APPLICATION NO.	FILING DATE	FIRST NAMED INVENTOR	ATTORNEY DOCKET NO.	CONFIRMATION NO.
09/741,521	12/20/2000	Paul Vegliante	2112-342 US	6443

Office Action Summary

DETAILED ACTION

Diagram 1. Figure 3 in Lucas.

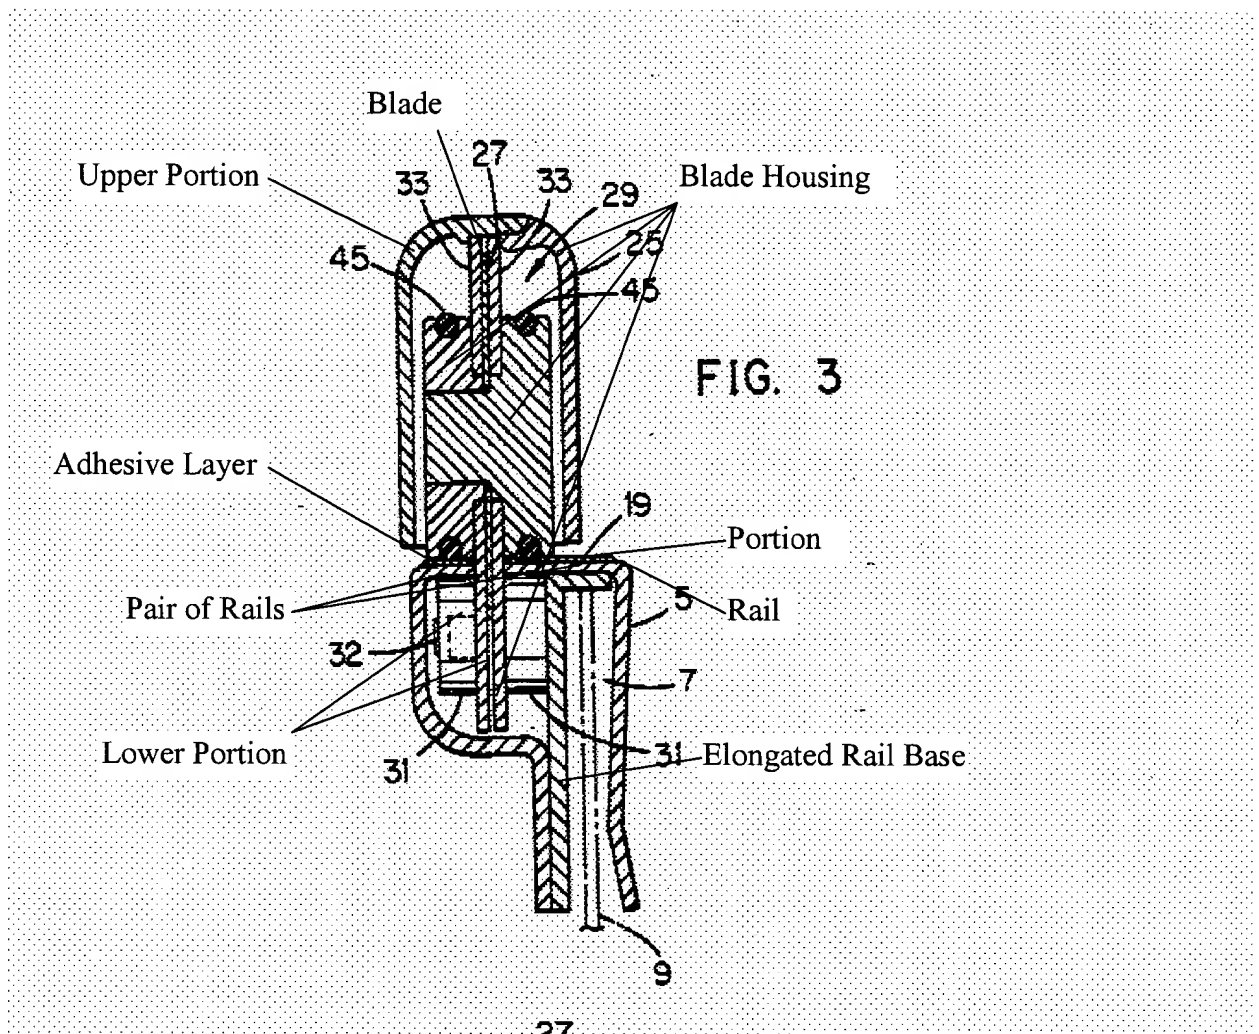
2. Claims 1, 6-15, 18 and 19 are rejected under 35 U.S.C. 103(a) as being unpatentable over Lucas, Jr. et al (5,440,961), hereafter Lucas, in view of Wankow (3,549,066). Lucas discloses everything as noted in Diagram 1; channel 13; bottom edge of upper portion of blade housing protrudes on either side of blade in figure 3; end surface of upper portion is rounded and inclined upward as shown in figure 2; tracking device 34; middle portion juxtaposed lower portion and upper portion; predetermined length and predetermined clearance of said middle portion shown in figures 2 and 3; tubular base 31; channel has tubular shape as shown in figure 3; left section 39; right section 35; rivet 37; aperture 51; blade angled from bottom edge at 30 degree angle as shown in figure 2; depression 7; rear edge 5; cover of a carton 9.
